Landmarks Review October 10, 2017

the MARC 27-29 Isabella St.

BOSTON LANDMARKS OCTOBER 10, 2017

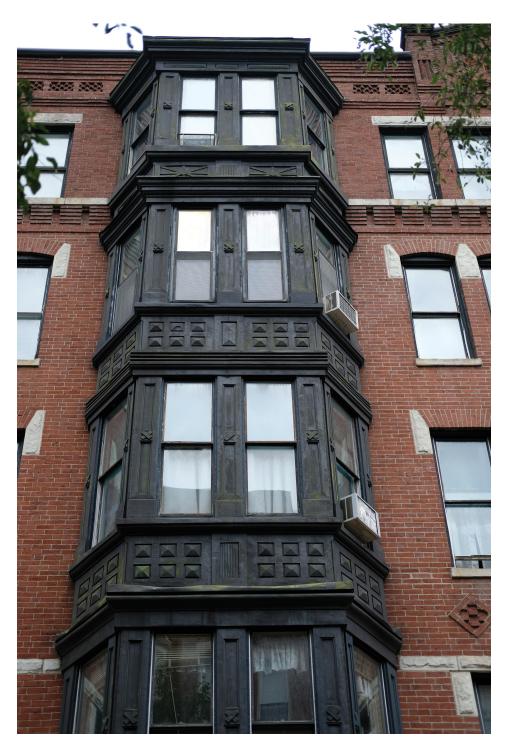
Specific information about the methods and materials to be used to repair the metal bays (what type of metal is there now, and is it currently painted).

In general the bay window projections are in good condition and not in need of repairs. If required we would be repairing with compatible materials and or replacing with similar materials (painted metal panel, dark green/black). It is undecided at this point as whether to leave the existing "aged" antique appearance, or whether to clean and paint the existing materials.

25 ISABELLA ENTRY

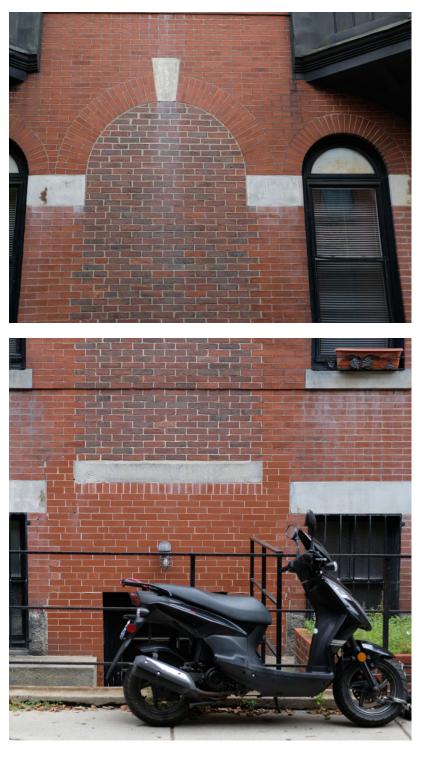
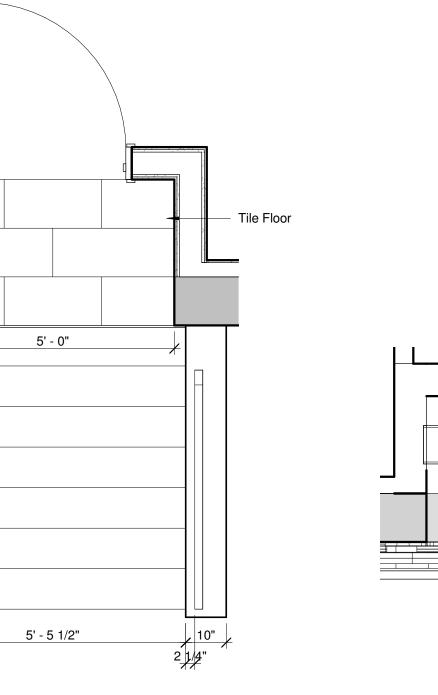
Please provide more specific information about the new entry at 25 Isabella Street (specific information about the door, transom and sidelights, the railings, and the new staircase).

At 25 Isabella Street the drawings indicate the subterranean pit will be retained; however the description of work indicates that it will infilled-please clarify what is being proposed for this area.

• Infill pit, incorporate into modest landscape to enhance public sidewalk and adjacent street edge (see example) -window sills at 25 Isabella level 1 to be raised to match sill height at level 1 / 27 Isabella (see elevation)

door: Solid core wood door with full or partial full lites

transom: frame material, shape, and treatment to match existing windows

sidelights: frame material, shape, and treatment to match existing windows, set in painted wood frame wall to match transom frame railings: black metal, 3/4" pickets, wood top rail

new staircase: concrete substructure with stone veneer (see elevation)

6" CONCRETE PAVEMENT SCALE: 1-1/2" =1'-0"

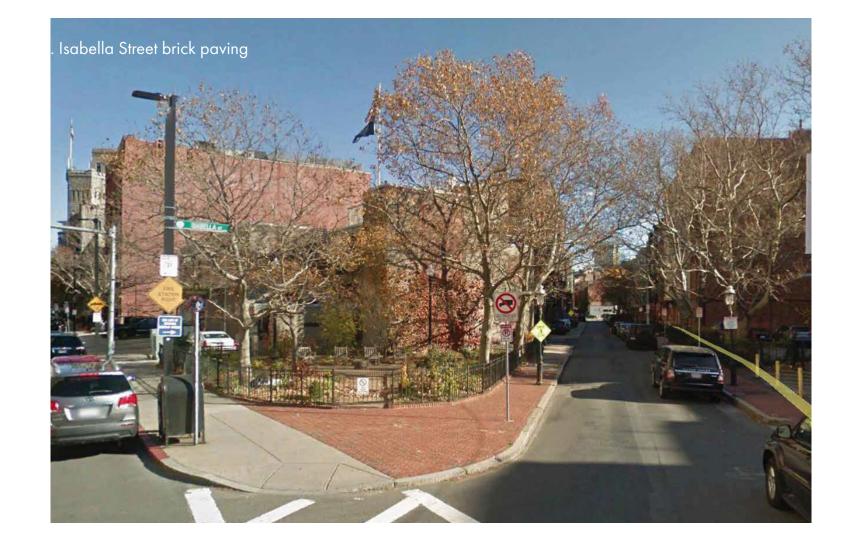
Regarding the proposed landscape changes, please clarify if the sidewalk paving will be changed and details (materials and dimensions) of the proposed curbing at the planting areas.

• Final landscape design not yet decided – modest improvements at building and street edges to enhance public realm and safety/walkability, including 5' concrete side walk, and plantings/pavings in spirit of Bay Village.
